MEMORANDUM

PROJECT: Kirkwood Road Signal Optimization and Interconnect Project &
South Kirkwood Road-Nipher Middle School Safe Route to School Project

SUBJECT: Addendum No. 2

PROJECT NUMBER: CMAQ-5502(605) & TAP-5502(607)

1. Revised Sheet 2, Typical Sections & General Notes, Sheet 1 of 3.

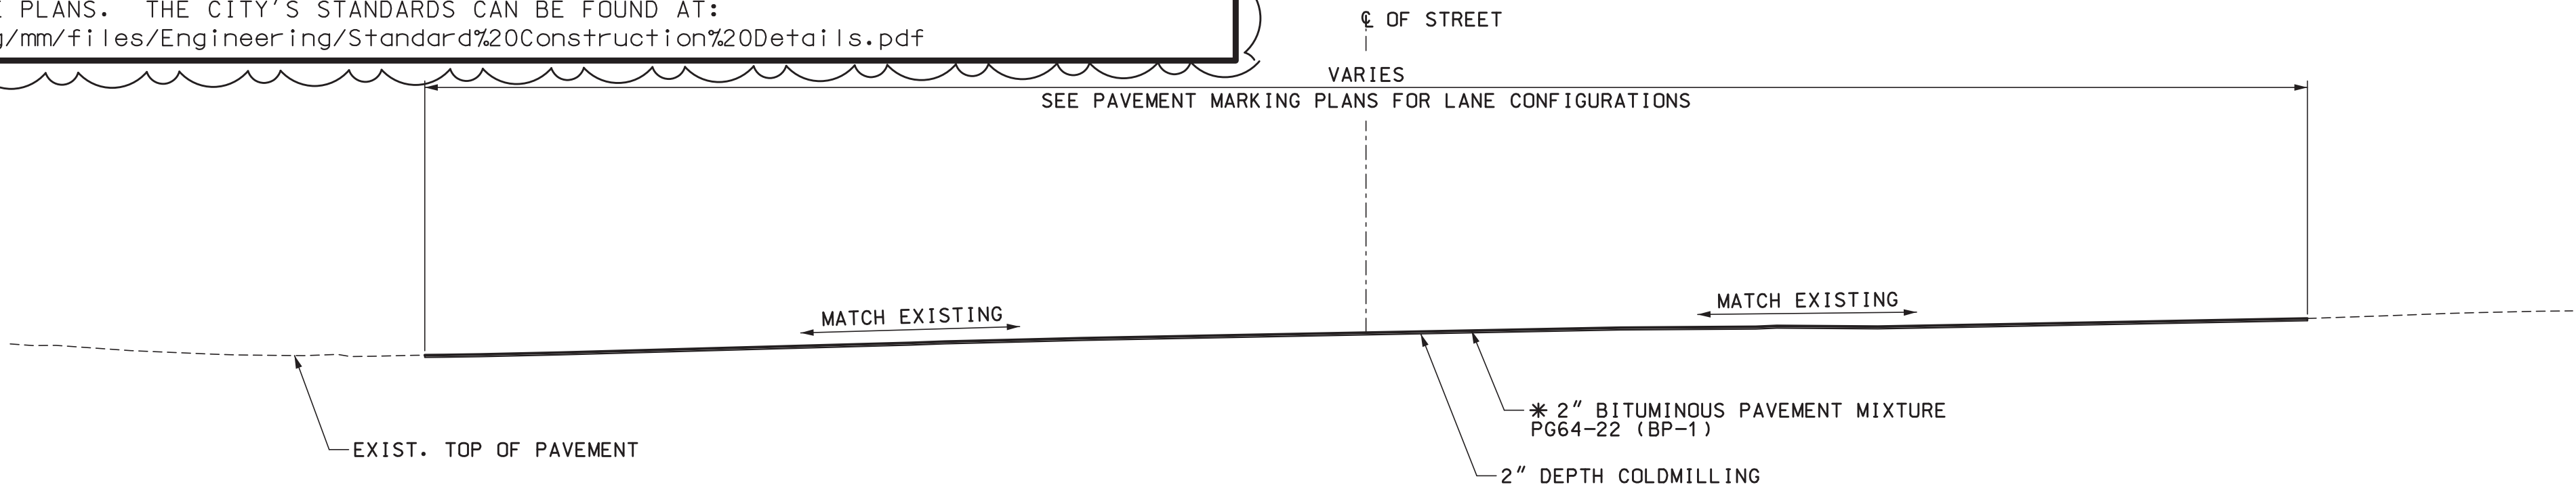
Added General Note 16:

- Added a note to specify the City's standard drawings and detailed specifications for pavement restoration for any disturbed areas during construction within City R/W and a note to use MoDOT's Specifications and Standards for pavement restoration for any disturbed areas during construction with MoDOT R/W.

16. THE CONTRACTOR SHALL FOLLOW THE CITY OF KIRKWOOD’S STANDARD DRAWINGS AND DETAILED SPECIFICATIONS FOR PAVEMENT RESTORATION FOR ANY DISTURBED AREAS DURING CONSTRUCTION INSIDE CITY R/W. THE CONTRACTOR SHALL FOLLOW MODOT SPECIFICATIONS AND STANDARD PLANS FOR PAVEMENT RESTORATION FOR ANY DISTURBED AREAS DURING CONSTRUCTION INSIDE MODOT R/W. THIS INCLUDES, BUT NOT LIMITED TO, BORING OPERATIONS, PAVEMENT CORING, AND ANY OTHER NECESSARY WORK NEEDED FOR CONSTRUCTION OPERATIONS. NO ADDITIONAL PAYMENT WILL BE MADE TO RESTORE THE AREAS BACK TO THEIR ORIGINAL CONDITIONS, UNLESS SPECIFICALLY SHOWN ON THE PLANS. THE CITY’S STANDARDS CAN BE FOUND AT:
<http://www.kirkwoodmo.org/mm/files/Engineering/Standard%20Construction%20Details.pdf>

2. **Revised Sheet 155 (Signal Sheet at Big Bend Road).**

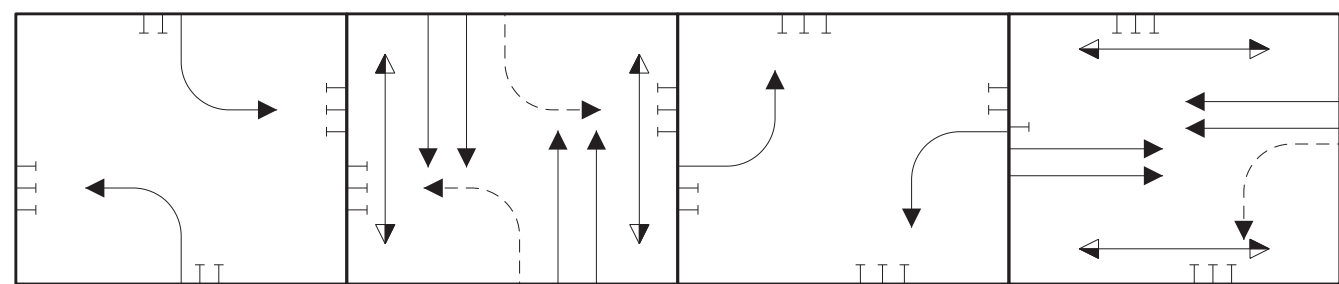
Clarified that the Uninterruptible Power Supply shall be mounted on the side of the signal cabinet:

- Revised the New Signal Cabinet call out to say:

“New Signal Cabinet; Uninterruptible Power Supply shall be mounted on the side of the signal cabinet”
